MEMORANDUM

Date:	April 9, 2013		
To:	University Station Development Team	Project #: 4410	USW 1217 University Station
From:	Don Leighton		
Subject:	University Station – Peer Review

The purpose of this memorandum is to provide and update to our Urban Design and landscape comments based on the Proponents March 22, 2013 Plan Submission. As the plans near completion the following items are noted.

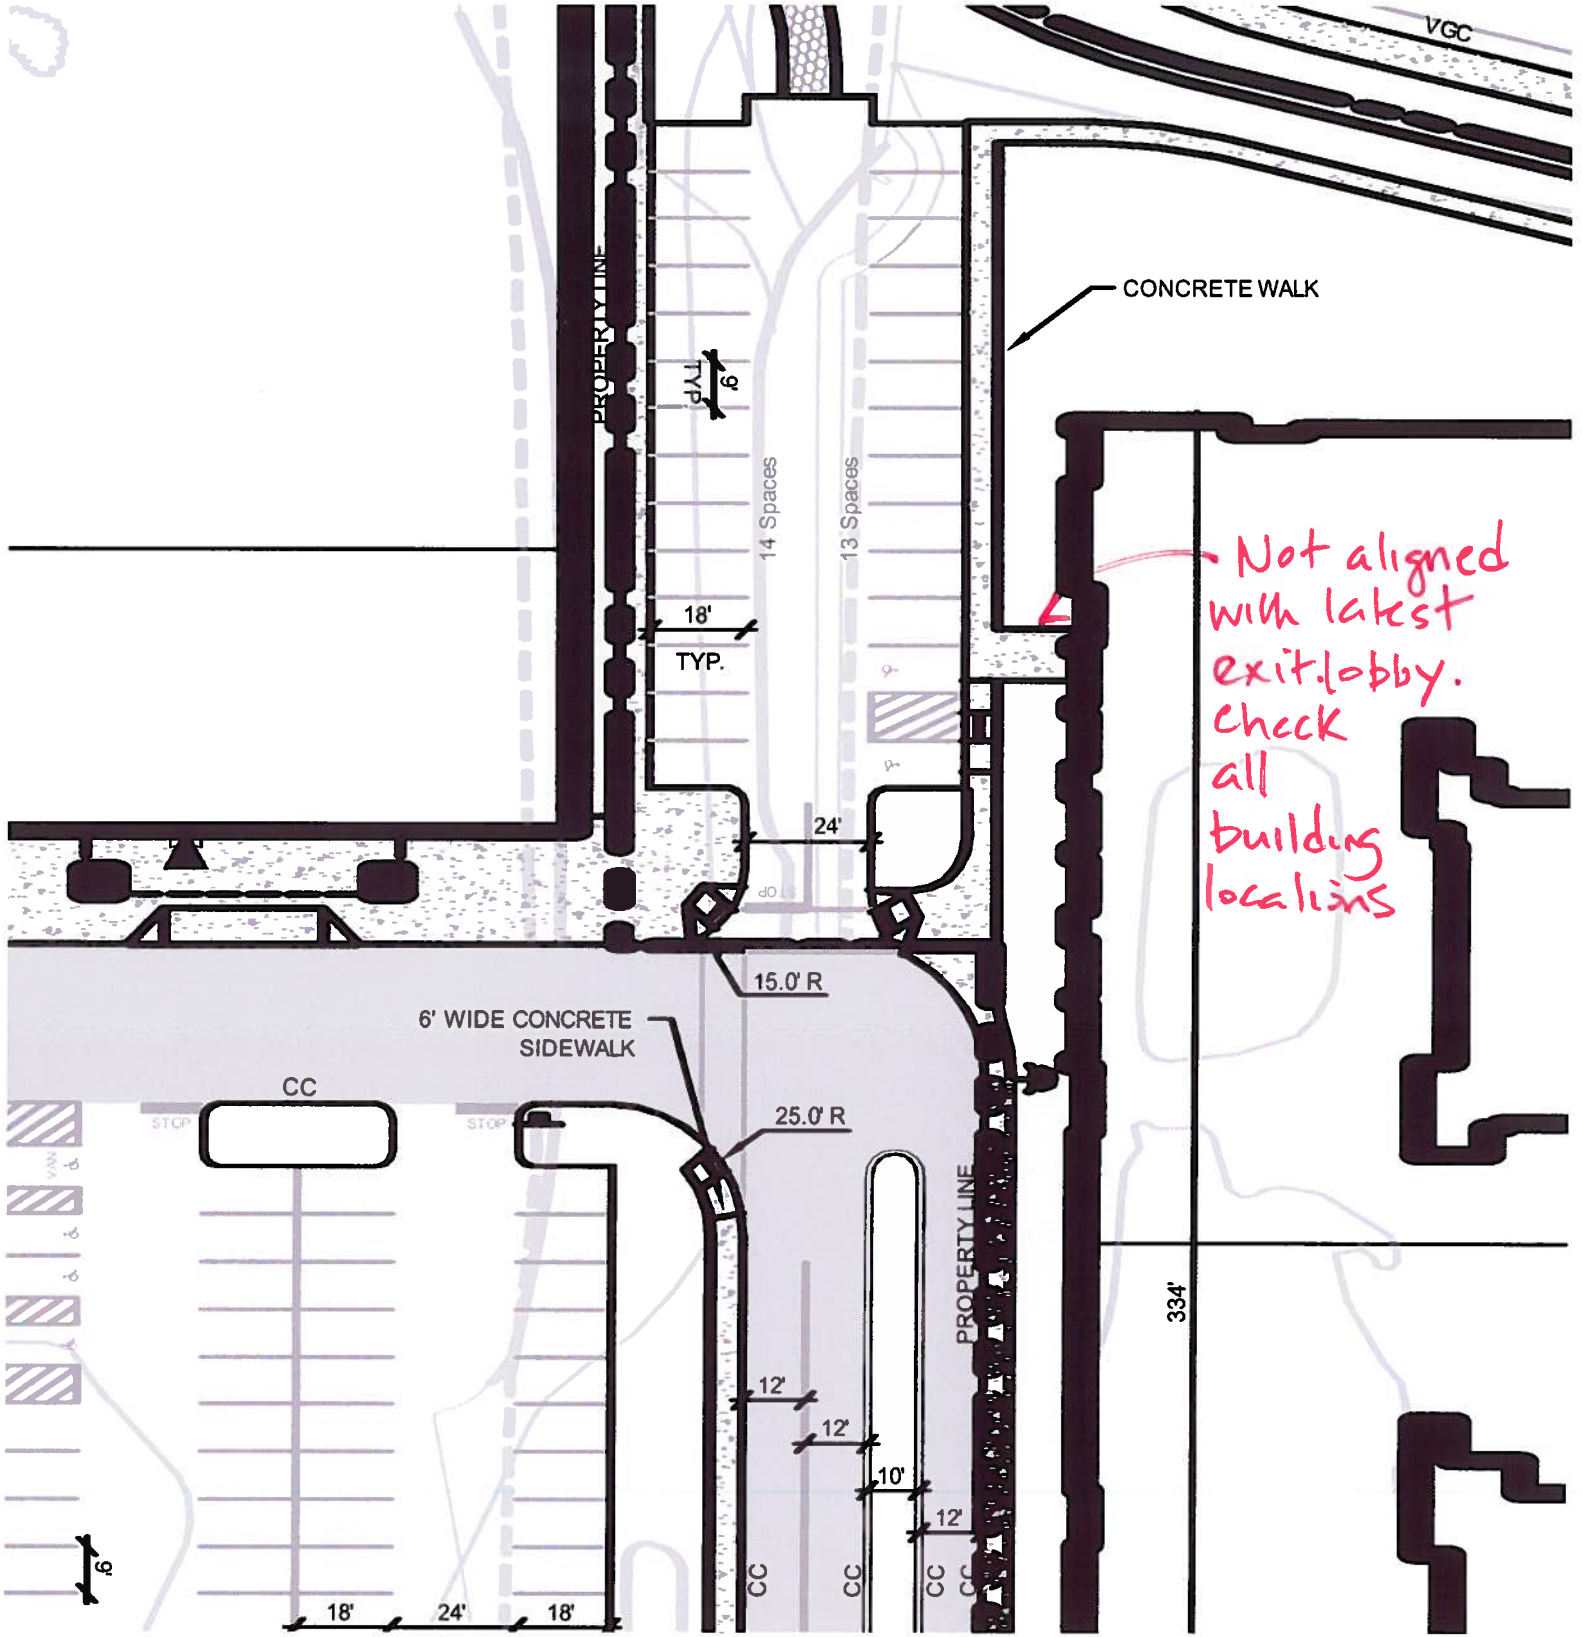
A-7) Adjust walk layout in the Meadow and around the assisted living facility to improve continuity and connections. See attachment 1 for additional comments.

Not aligned with latest exit lobby. Check all building locations
